GGT - Goldfields Gas Pipeline

REVIEW OF TECHNICAL ASPECTS OF GGT ACCESS ARRANGEMENT 2025-29

Report prepared for:
**ECONOMIC REGULATION
AUTHORITY**
July 2024

Figure 3.1: GGT's SIB project cost estimation process

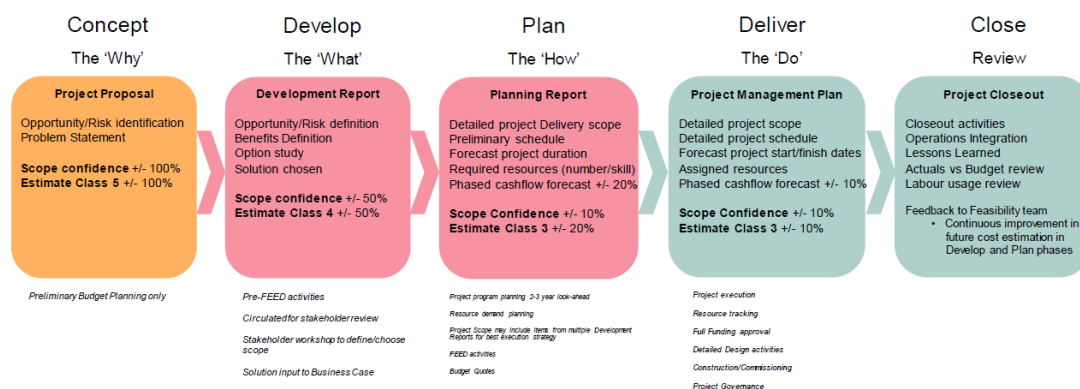
133. We consider GGT’s cost estimation process to be adequate except for the very broad range of estimate accuracy for its ‘concept’ stage projects. It quotes AACE³⁶ Class 5 accuracy of $\pm 100\%$ (refer to Figure 3.1). We received somewhat conflicting information regarding projects that are in the ‘concept’ planning stage. For example:

Figure 4.2: Variance analysis of proposed conforming AA4 capex compared with ERA’s FD by expenditure category (corrected) - \$m real 2023

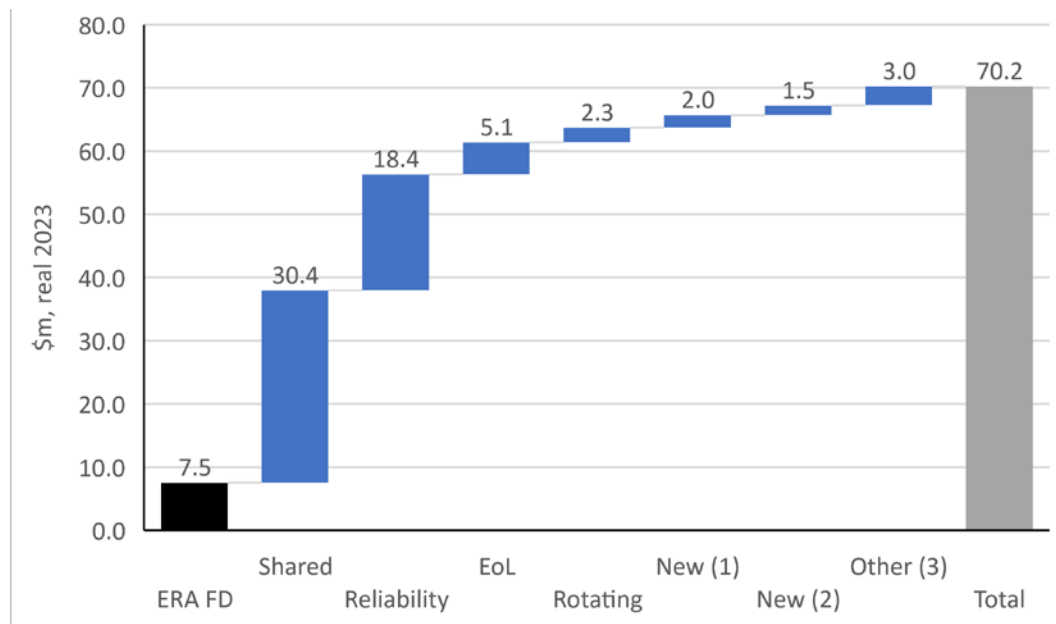
161. In Figure 4.2 we show the variance analysis between the proposed AA4 capex and the ERA’s FD by expenditure category. We note that for this purpose we utilise GGT’s proposed ‘allocation-corrected’ capex of \$70.2 million, however in GGT’s AA5 submission, GGT proposed \$10 million less than this amount, all of which is for ‘SIB’ capex.

Figure 5.3: Time trend of proposed and adjusted capex (\$m, 2023)

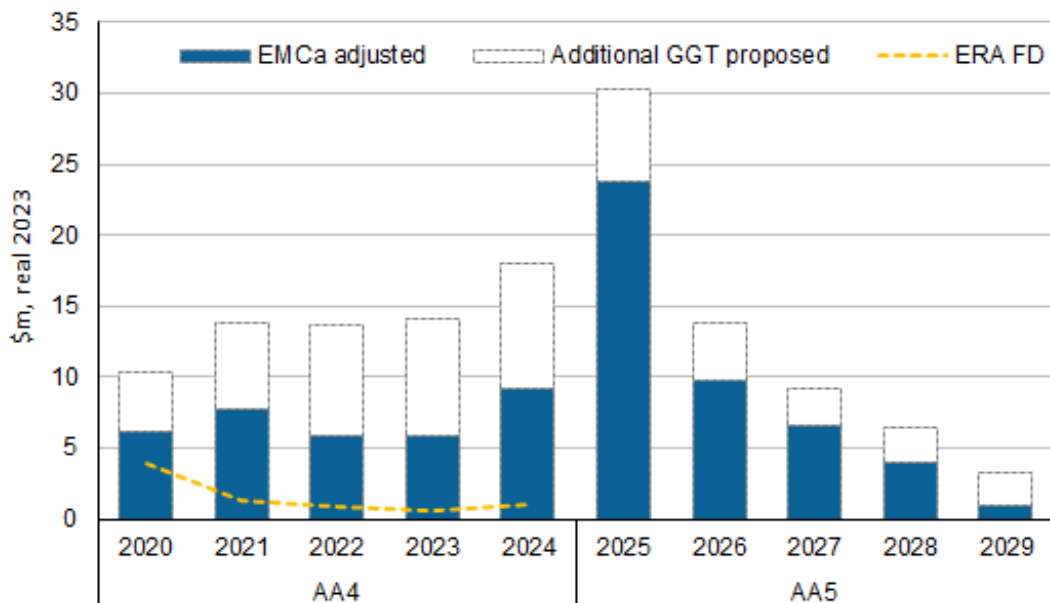
327. Figure 5.3 shows the time trend of GGT capex across the two regulatory periods. For each year, the dotted grey bordered columns show the amount that GGT has proposed, while the blue segments of each column show the adjusted amounts that we consider to reasonably represent conforming capex.

Figure 6.3: GGT's historical and forecast opex - \$m, real 2023.

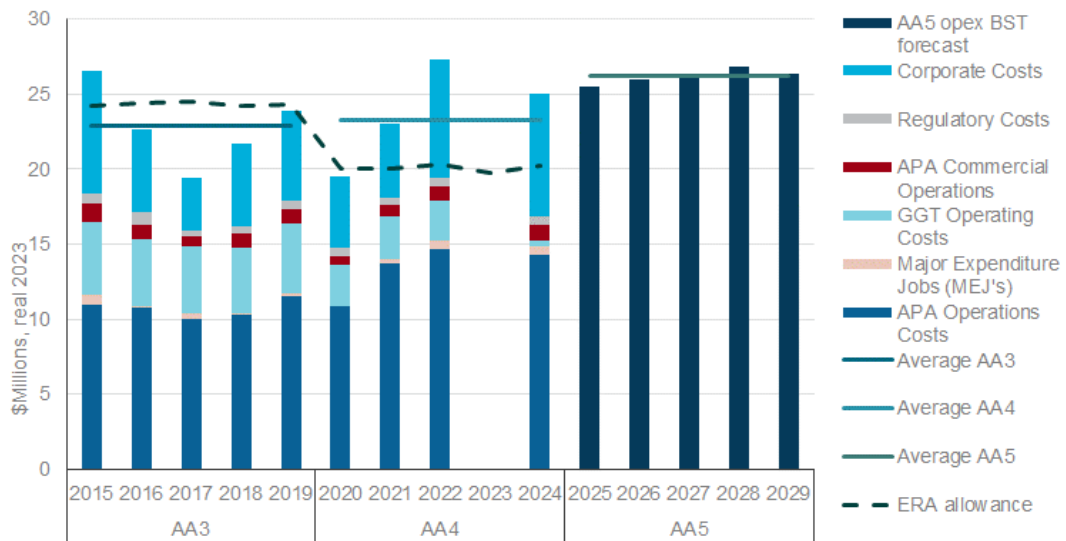
335. We provide the historical and forecast opex in Figure 6.3 to show the overview of GGT's opex long term trend. When compared with a relatively flat historical trend (though with annual fluctuations), GGT's proposed AA5 opex represents a clear trend upwards.

336. From the graph, it can also be seen that ERA's determination for the AA4 was significantly lower than its AA3 determination and GGT's actual AA3 expenditure, and significantly lower than GGT's actual expenditure to date in the current period. As GGT has noted in its AA5 submission, this is essentially because its submission for the current period, and therefore ERA's determination, were based on its 2017 actual expenditure as the 'base year', and this was below trend average levels.

348. An examination of GGT’s opex since 2015, as shown in Figure 6.3, shows significant year-on-year variability in its opex, with swings of up to +/- \$5 million evident in some years, relative to trend averages. The year 2017, which was GGT’s base year for its initial proposal for AA4, can be seen to have been a low year relative to trend, but expenditure in 2022 presents as much higher than trend. Because of this variability, we have paid particular attention to GGT’s 2022 expenditure by reference to prior expenditure trends, as we describe below.

Figure 6.4: GGT’s historical, forecast opex and EMCa adjusted - \$m, real 2023

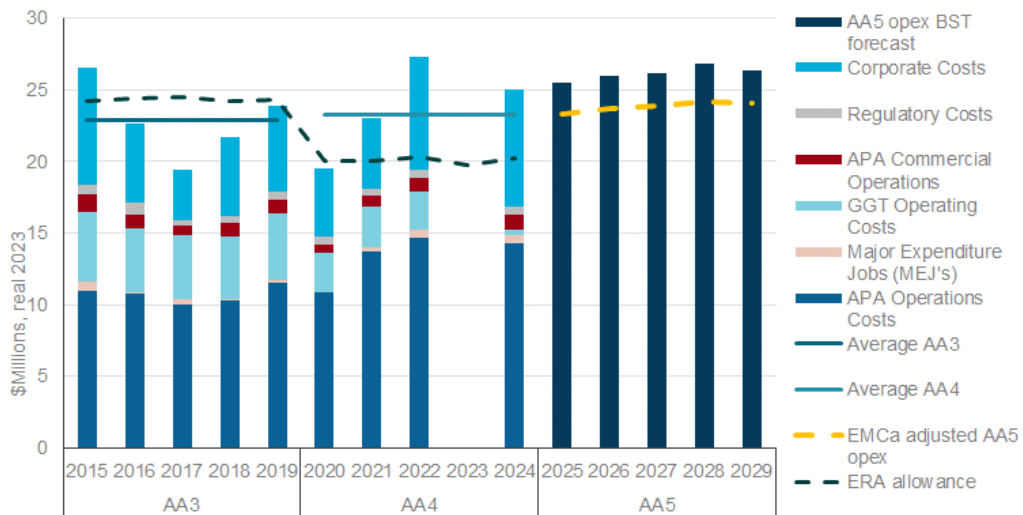
412. Figure 6.4 illustrates GGT’s proposed opex and the EMCa adjusted opex, by reference to historical trend expenditure. The adjusted expenditure represents a slight increase on average expenditure in the current periods, driven mainly by costs resulting from introduction of safeguard mechanism obligations and, to a lesser extent, real labour cost escalation.¹²⁶
